PLANNING COMMISSION

AGENDA ITEM: 3. Site Plan Review – Automotive Enterprises, Inc.

On June 13th, a revised final site plan, meeting minimum standards of Code Section 44.06 (b) (site plan ordinance) was submitted for the auto dealership. The full submittal package is attached. In accordance with Council request, the Planning Commission was scheduled to consider the plan on June 23rd. Notice of this schedule, along with copies of the submitted plan (11 X 17 format) were forwarded to all property owners who had received notice of the zone change. Copies of the plan were also forwarded to staff of the City site plan review team with the invitation to conduct an "in-house" review of the plan on June 17th. Given this review, the following comments/corrections were presented:

1 SITE PLAN PHOTOMETRIC LIGHTING PLAN
E-1.0 1" = 30'-0"

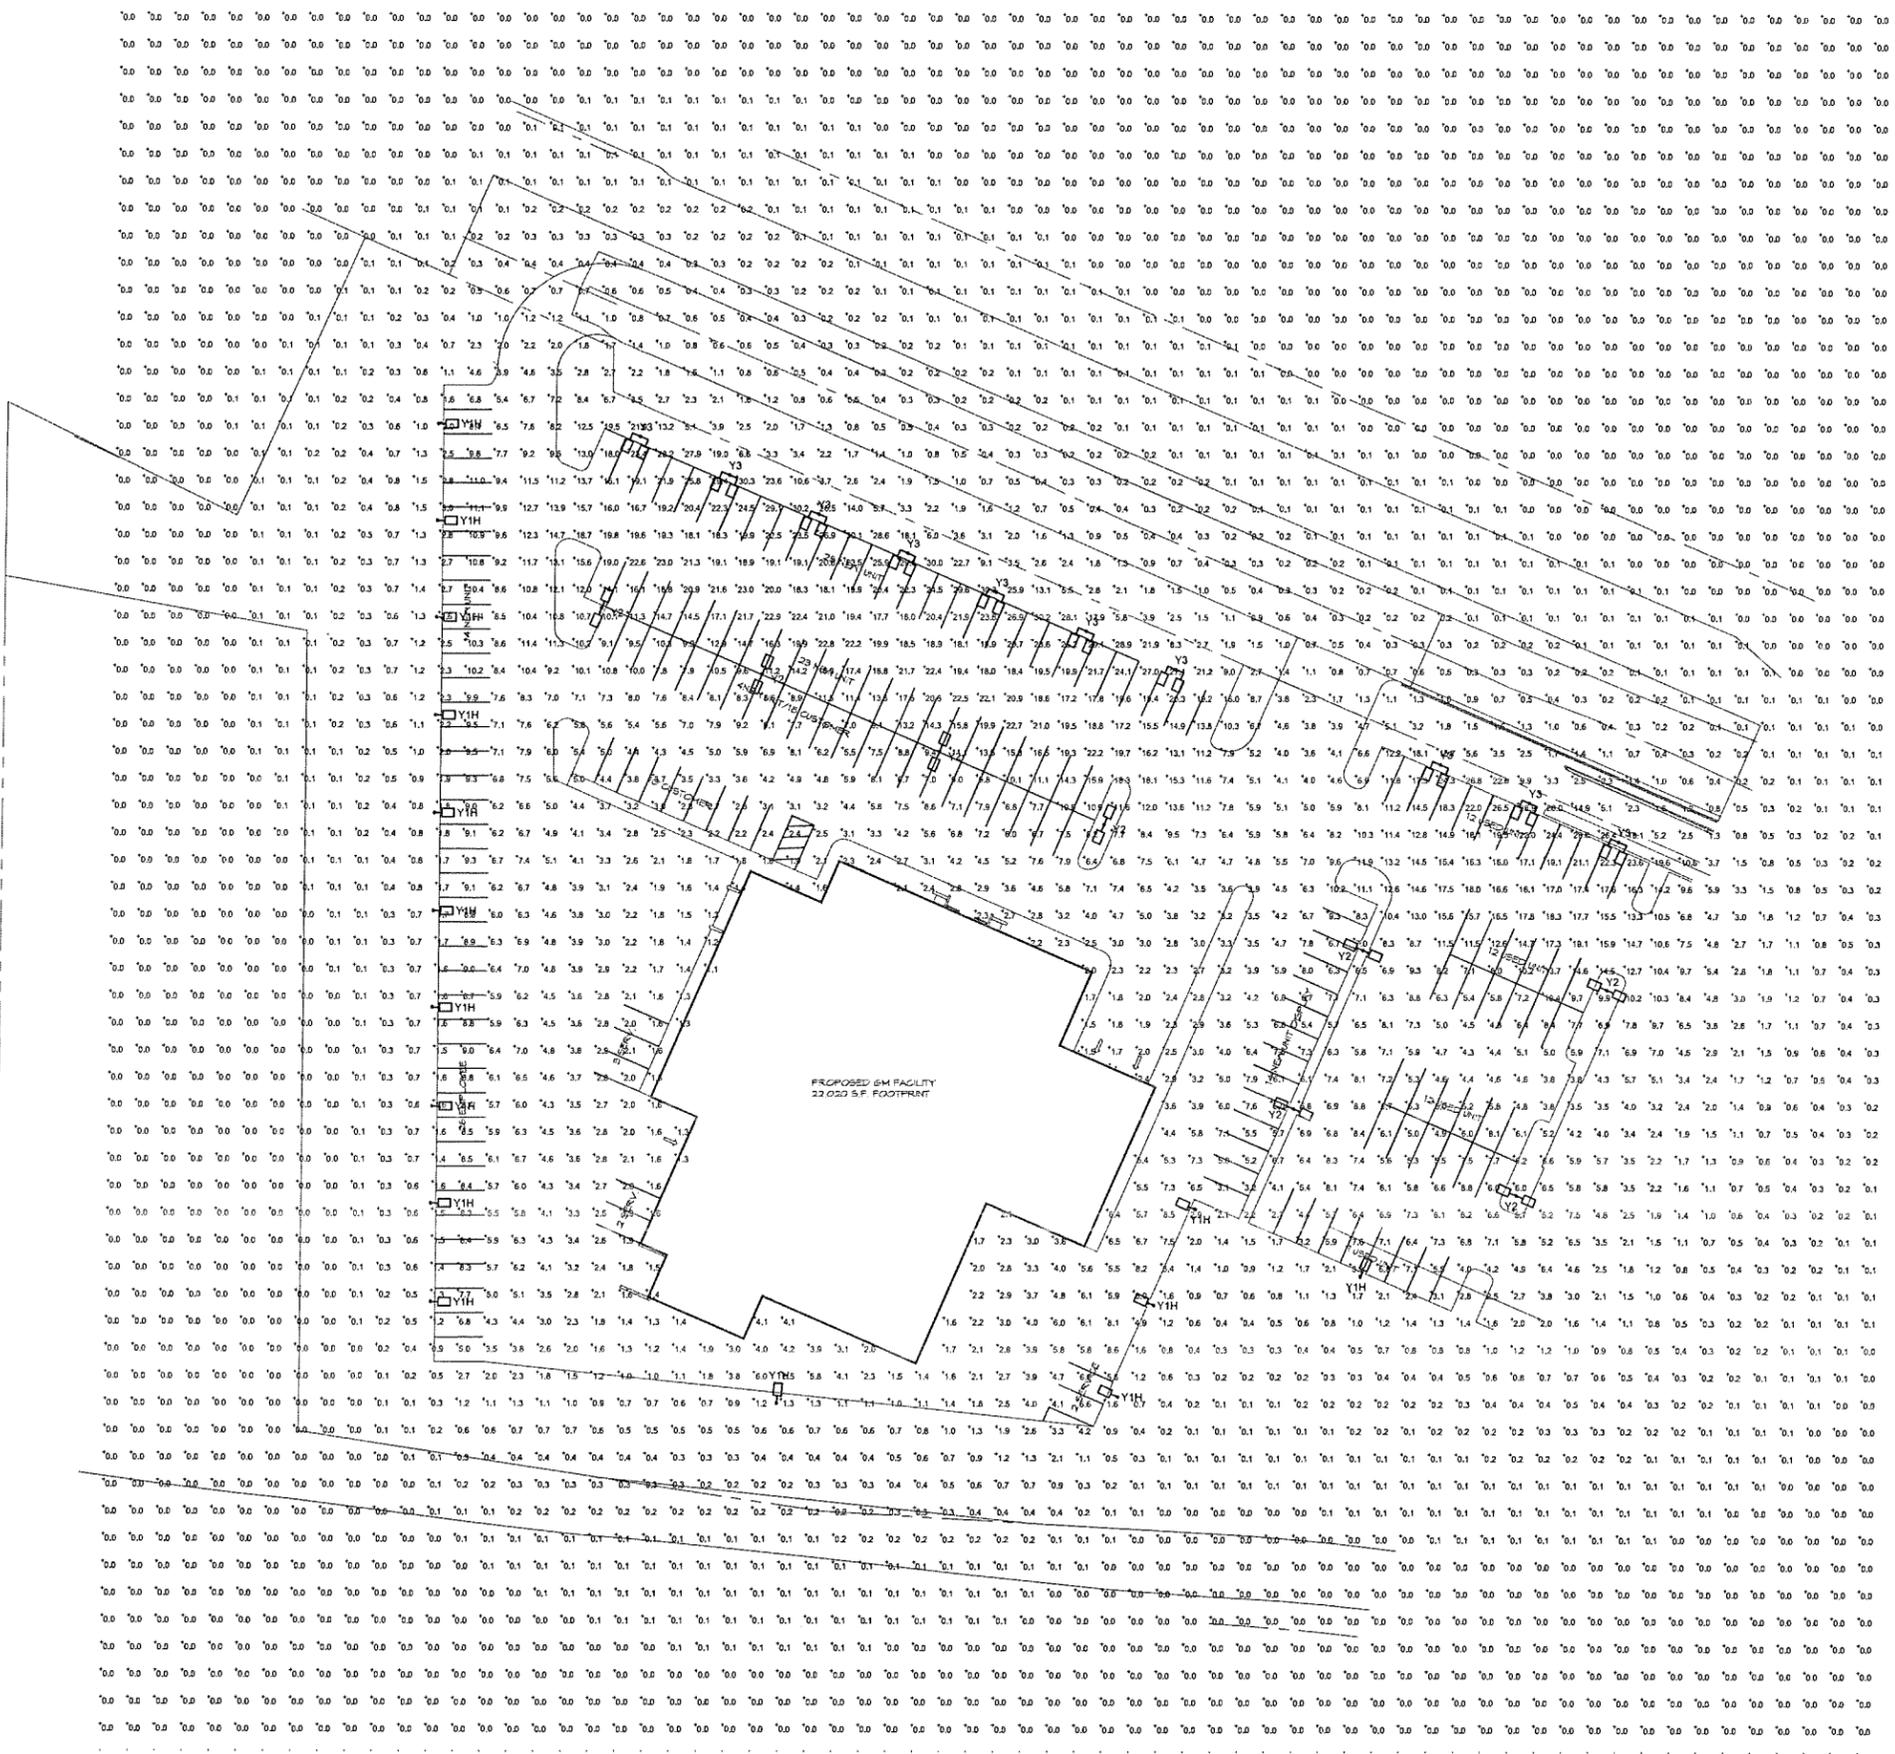
- **Lighting.** Given that the zone change will promote commercial use closer to the Johnstone Addition area, the effect of parking lot lighting was a major concern during the rezone process. In addressing this, the site plan package does include a proposed lighting plan showing the location/type of lighting fixtures proposed. As noted, proposed fixtures will be of LED style scattered at designed intervals throughout planned parking areas. Poles will be at heights of 26 feet. Given LED lighting, and planned “orientation” of fixtures, the lighting plan also includes a photometric lighting schedule that certifies the effect of lights on adjoining property. Given this schedule, both direct/indirect lighting impacts on adjoining residential property should all but cease at west and south property lines of the development site. To clarify, this does not mean that lit objects won’t be seen from outside of the site. However, this form of light fixture does minimize spill over (light pollution) that is often encountered with other forms of fixtures (sodium/mercury vapor, etc.).
